V2500-A5/D5 SERIES PROPULSION SYSTEMS SERVICE BULLETIN

V2500-ENG-72-0511

ENGINE – NEW 1ST STAGE ROTOR ASSEMBLY WITH METERING PLUGS REMOVED AND NEW 1ST STAGE
HPT SEAL

Figure 1

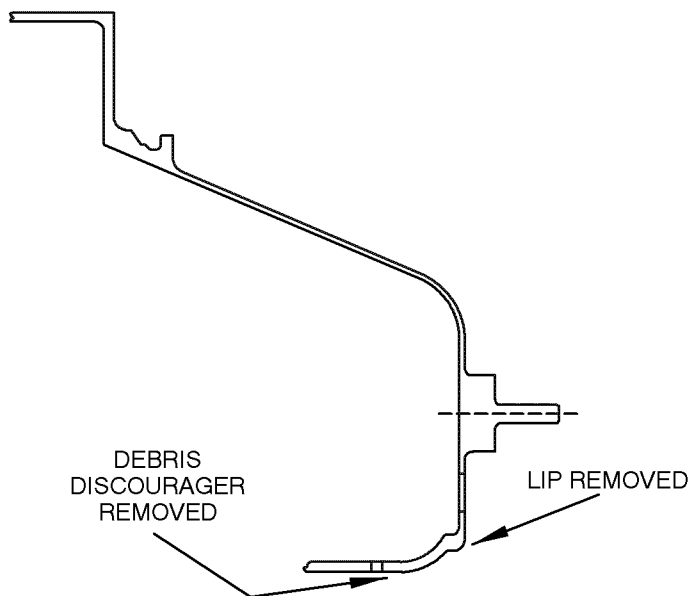
NOTE: Check the number 4 Bearing Rear Cooling Duct Assembly to insure the intent of V2500-ENG-72-0190 Service Bulletin is incorporated. If debris discourager and lip require removal, reoperate and reidentify per V2500-ENG-0190. See Fig.1.

NUMBER 4 BEARING COOLING DUCT ASSEMBLY
PRIOR TO INCORPORATION OF V2500-72-0190

NUMBER 4 BEARING COOLING DUCT ASSEMBLY
AFTER INCORPORATION OF V2500-72-0190

INSTALLATION OF DAMPER AND SEAL ON 1ST STAGE TURBINE ROTOR ASSEMBLY
Figure 2

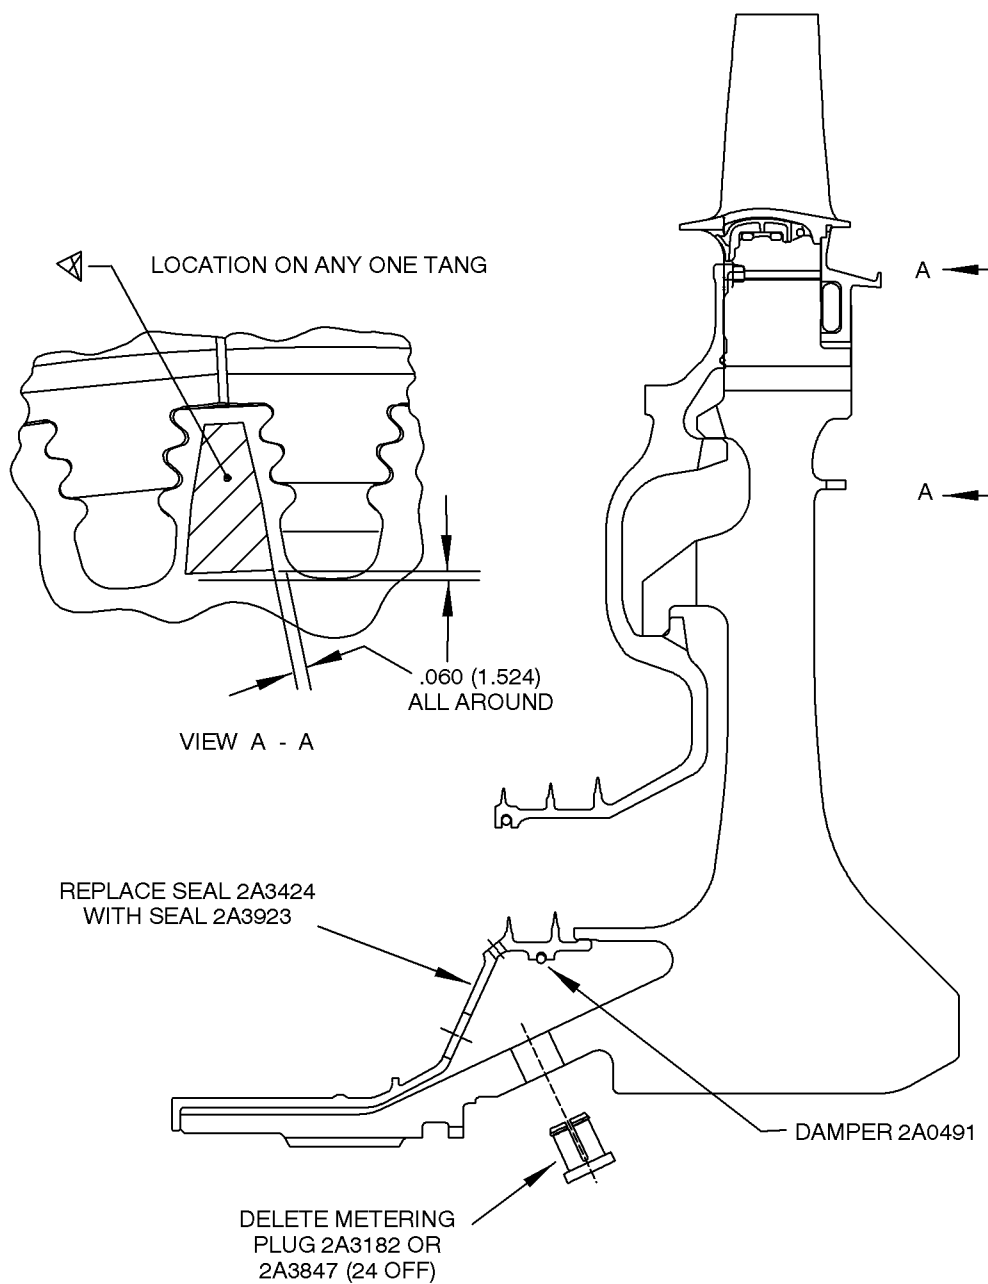
(i) Remove HPT Seal (P/N 2A3424). See Fig. 2.

(ii) Remove Damper (P/N 2A0491). See Fig. 2.

(iii) Remove 24 Metering Plugs (P/N 2A3182 or 2A3847) and scrap. See Fig. 2.

(iv) Clean and Inspect Damper (P/N 2A0491) per the Engine Manual Task 72-45-13-100-001 and 72-45-13-100-002. See Fig. 2.

(v) Install a servicable or new Damper (P/N 2A0491) on the new Seal (P/N 2A3923). Install the Seal with Damper on the 1st Stage Rotor. See Fig. 2. Insure HPT Seal is fully engaged.

FAMILY TREE – TURBINE ROTOR 1ST STAGE ASSEMBLY OF REF. CATALOG SEQUENCE NO. 72-45-10
 FIGURE 01 ITEM 10
 CHART A (Sheet 1 of 2)

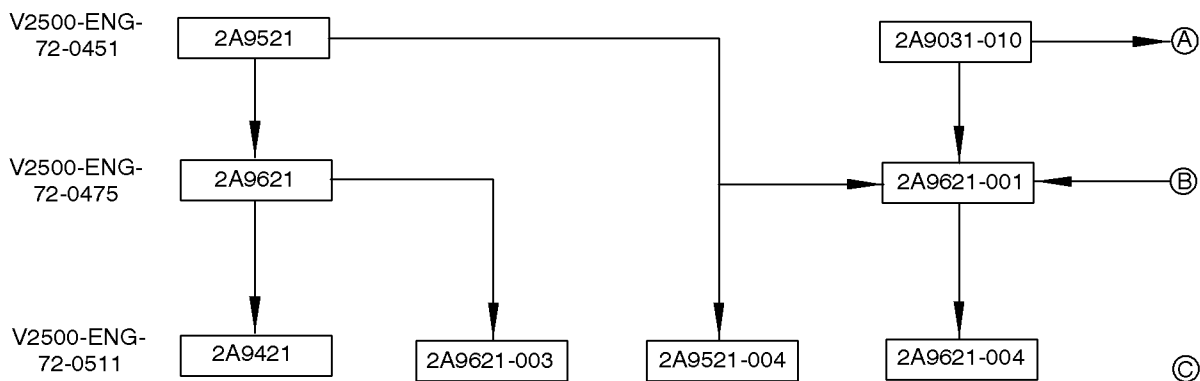
MODIFICATION

PART NUMBER CHANGE

FAMILY TREE – TURBINE ROTOR 1ST STAGE ASSEMBLY OF REF. CATALOG SEQUENCE NO. 72-45-10
 FIGURE 01 ITEM 010
 CHART A (Sheet 2 of 2)

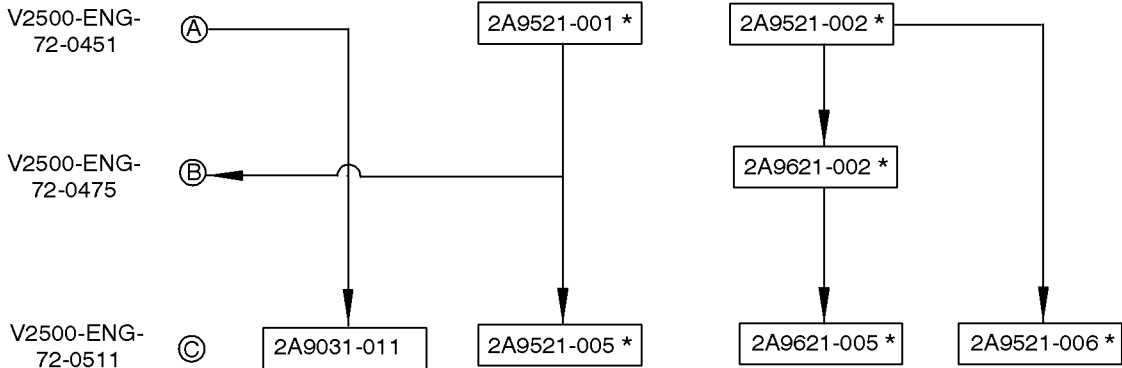
MODIFICATION

PART NUMBER CHANGE

* DO NOT USE IN MODEL V2533-A5
